DESIGN REVIEW BOARD MEETING

7:30 p.m. Monday, July 6, 2020

Re: Information regarding 31279 Old Stage - New Home

SHEET #
A5

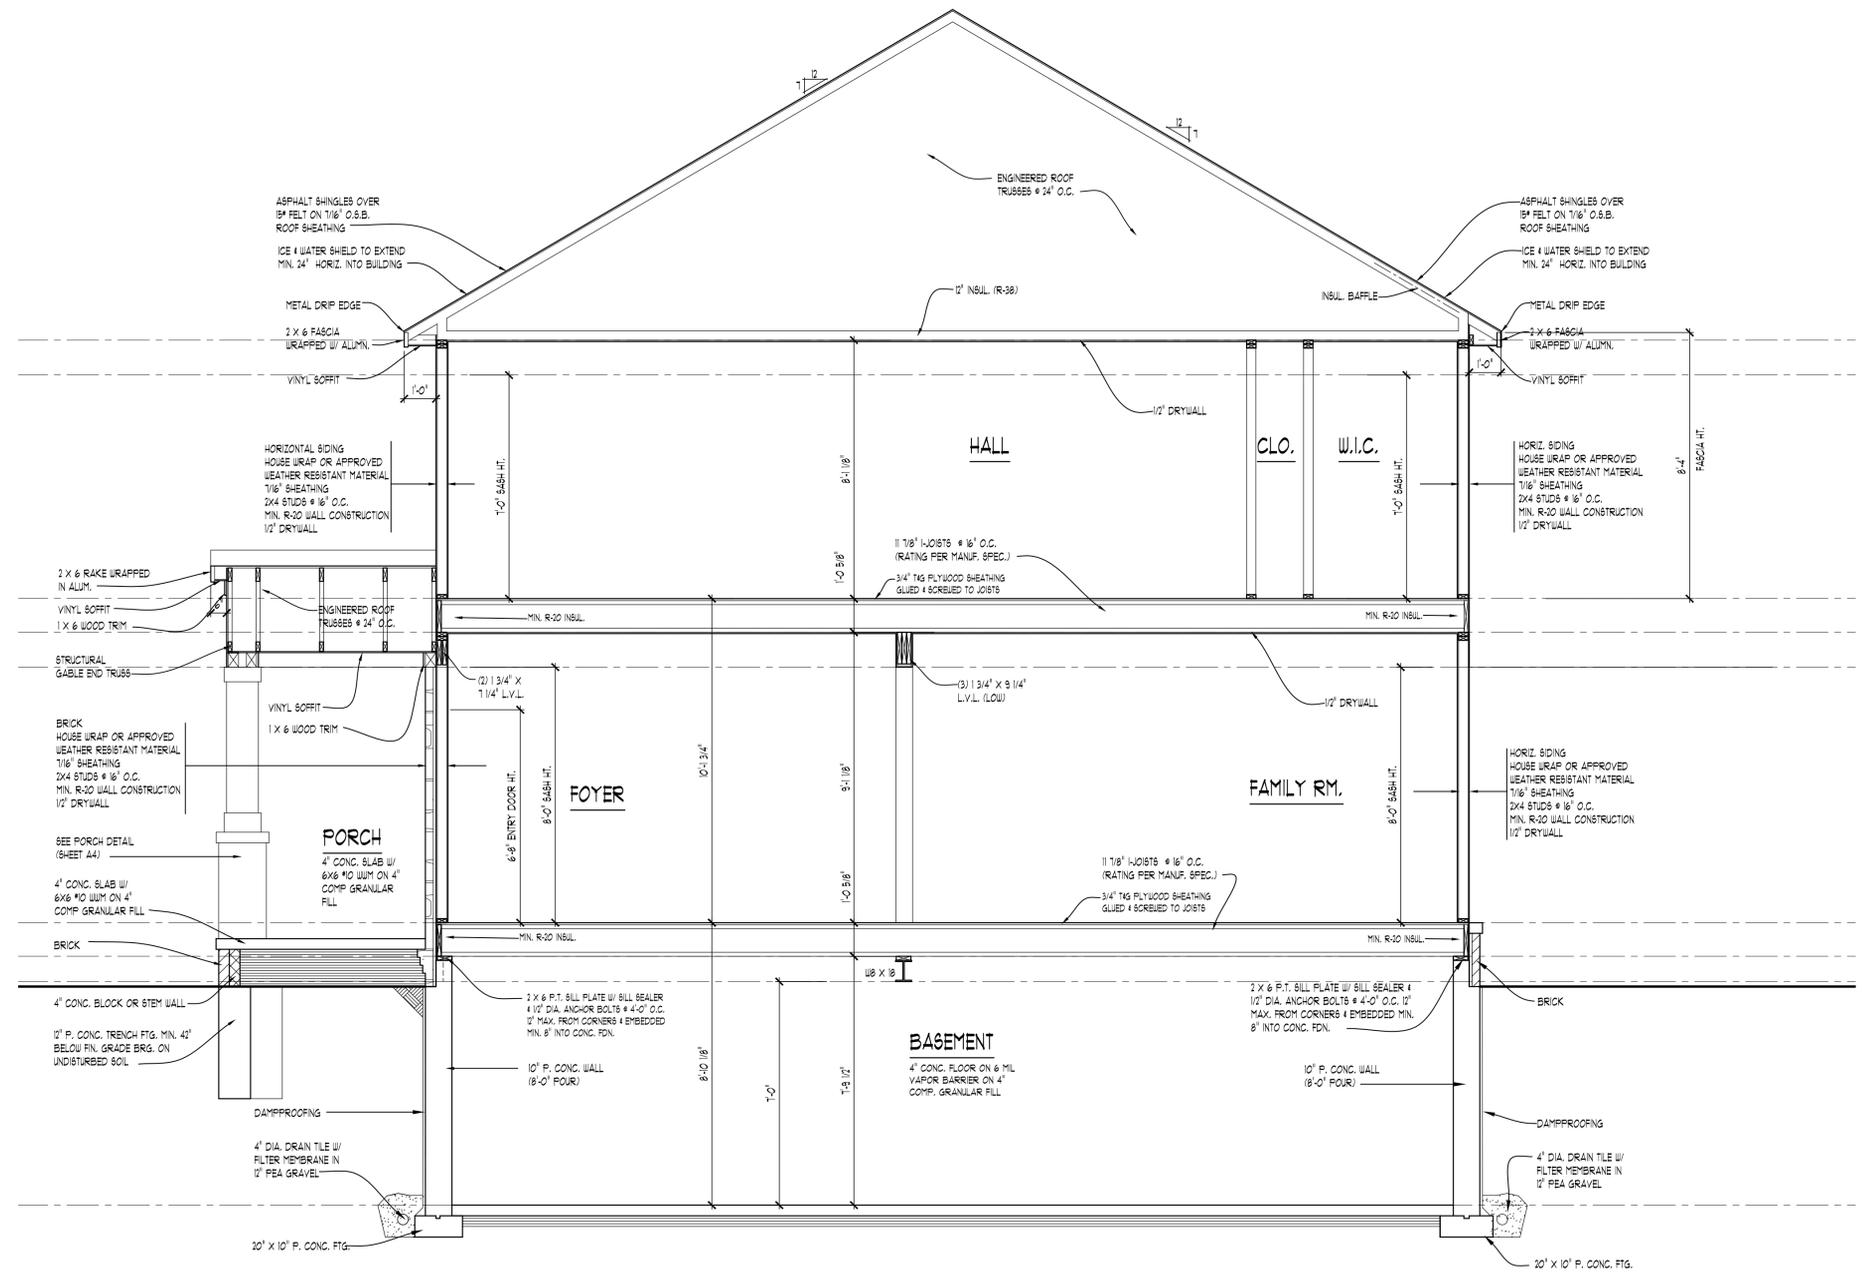
a. 31279 Old Stage Rd: New Home Plans. Haytham Obeid, builder, presented plans for the new home. Board discussed plans and offered design suggestions: add window(s) to south façade, change front porch column design, replace vinyl with different material such as Hardie board. Motion by Hagaman to table plans until July meeting pending resubmission. Second by Grenadier:

The board tabled a decision regarding approval and suggested several alterations regarding the home's design (see the June 1, 2020 minutes in this meeting's packet under agenda item III):

- Add window to the south façade. This is shown on page A-5 of the revised plans.
- Change the design of front porch columns. This is shown on page A-4 of the revised plans.
- Replace vinyl with a different material, such as Hardie board. This is shown in one of the color/materials attachments
